# 1959 - 1961 Corvette: Service News: Fuel Injection Change

**Subject:** Fuel Injection Change

**Model and Year:** 1959 - 1961 Corvette

**Date:** July, 1961 - Volume 33 - Number 7

*Fig. 2—Fuel Injection Cold Enrichment*

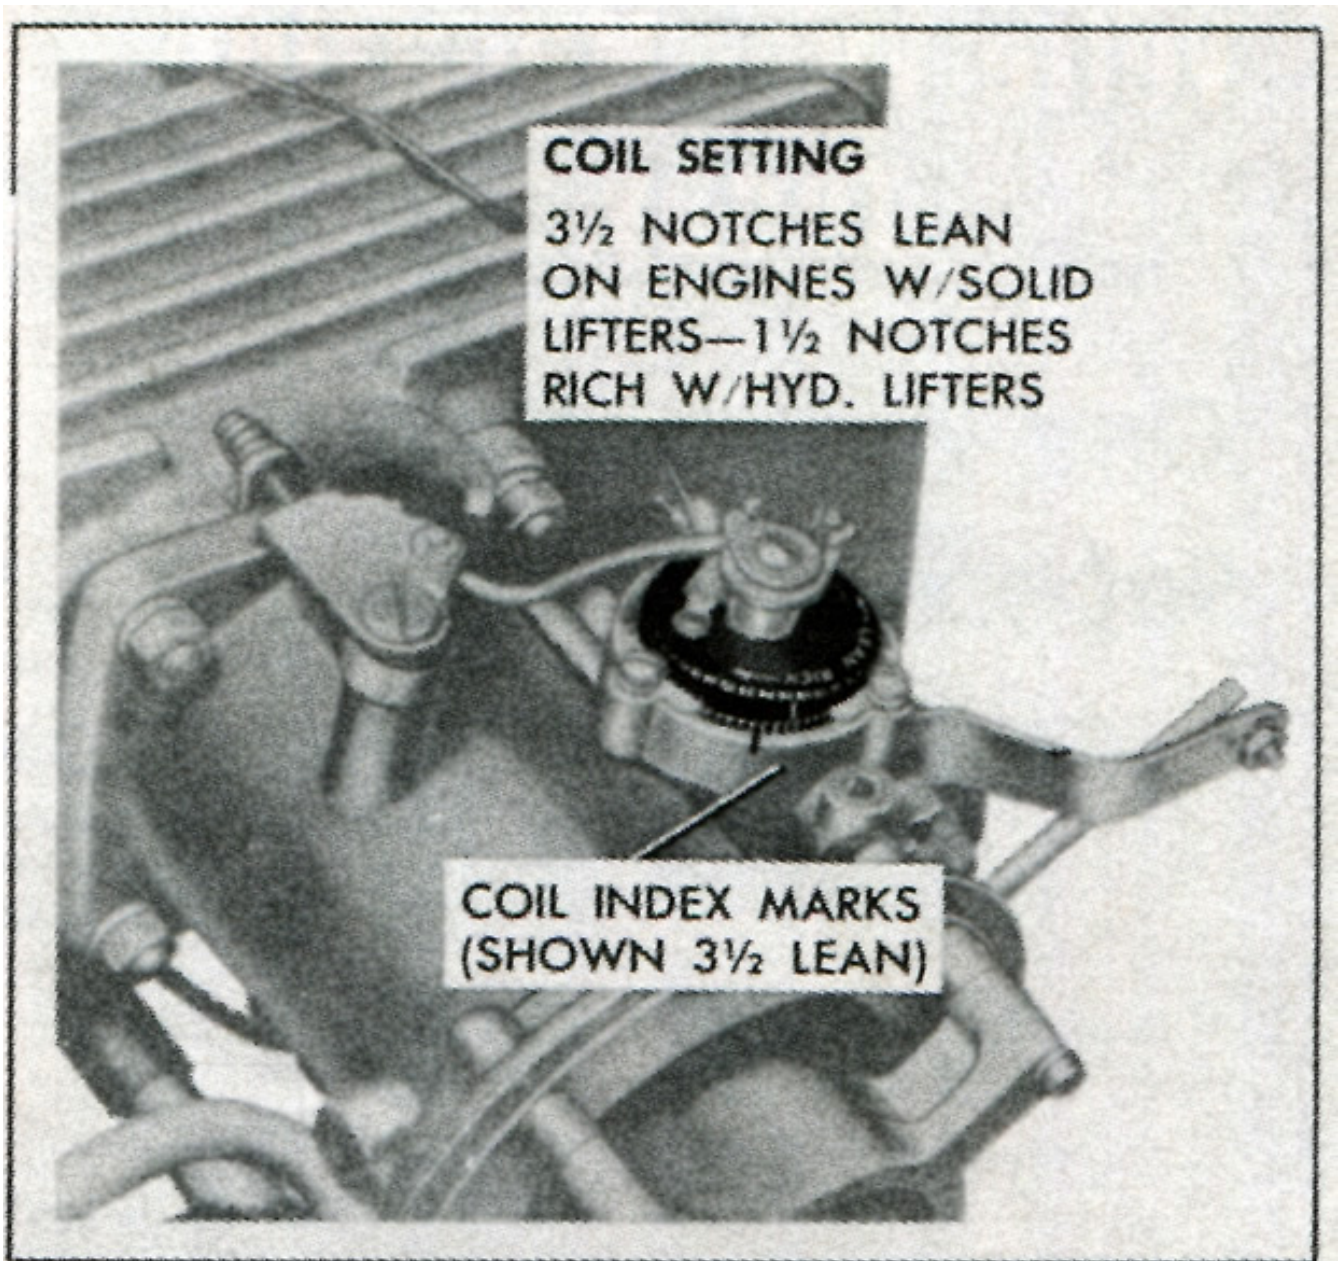
On 290 hp Corvette engines used in 1959 and 315 hp used in 1960 - 1961, the cover setting of the fuel injection thermostatic coil, that provides cold engine fuel enrichment, should be adjusted to 3 1/2 notches lean from the index mark on the cold enrichment housing (Fig. 2). The cold enrichment coil setting of 1 1/2 notches rich will still be used on all fuel injection engines of lower horsepower.
